Service Bulletin

Subject: Mag Timing Housing- Dowel Pin

Date: 02/23/2017

This Service Bulletin informs owners and operators of aircraft equipped with Electroair 6-cylinder Mag Timing Housings (MTH), Part numbers EA-10000 or EA-12000, approved under Supplemental Type Certificate SA03286CH.

Figure 1: Modified MTH

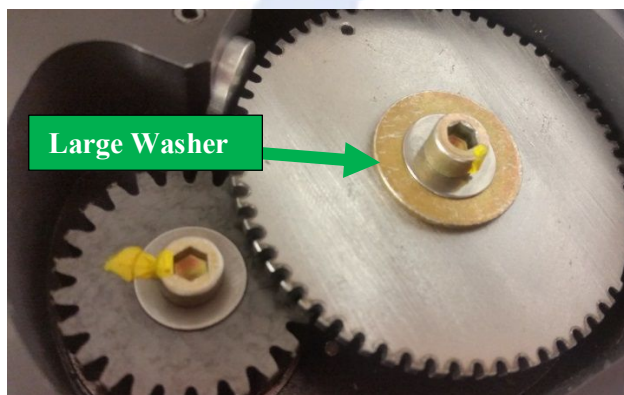
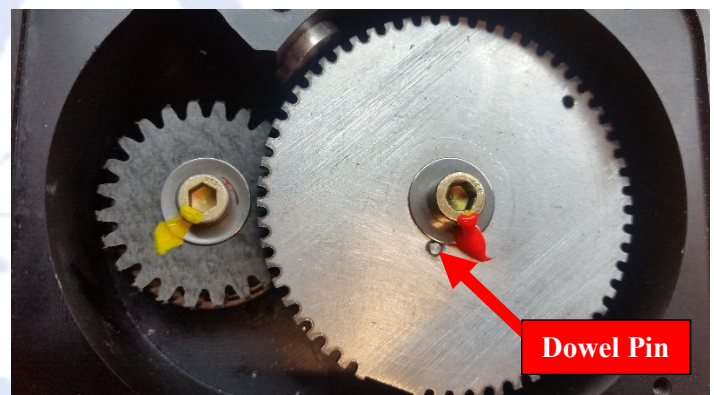
Electroair has received reports of the 6-cylinder Mag Timing Housing (MTH) malfunctioning. The malfunction may cause the trigger wheel within the MTH to become loose due to a dowel pin withdrawing from its designed position. If this happens, the electronic ignition system may not function correctly. The engine timing from the electronic ignition system may slip, and the engine may run rougher than normal. A pilot may notice either a rough running engine, or may notice slightly elevated or slightly decrease cylinder head temperatures.

Electroair has established a method to modify the EA-10000 and EA-12000 in order to prevent the dowel pin from becoming loose.

Owners and operators of aircraft equipped with the referenced EA-10000 or EA-12000 6-cylinder Mag Timing Housings (MTH) can inspect the MTH to see if it has already been modified. To check for the modification, first remove the bottom cover of the MTH unit. Use caution with the screws, because those are brass screws which can easily be cross threaded. Once the cover has been removed, simply visually inspect the top of the trigger wheel. If you see a large washer under a smaller washer and screw, then the MTH unit already has been modified (Figure 1). If you see only a small washer and the dowel pin, then the MTH has not been modified (Figure 2).

If your unit (Figure 2) contains only a small washer, and you can see the dowel pin, then your unit should be returned to Electroair for service and modification.

What Electroair will do: Affected serial number Mag Timing Housing (MTH) unit owners should contact Electroair and schedule the modification. Units that have NOT been modified with the larger washer may be returned to Electroair for modification/alteration to be configured into the latest design. There will be no charge for this modification.
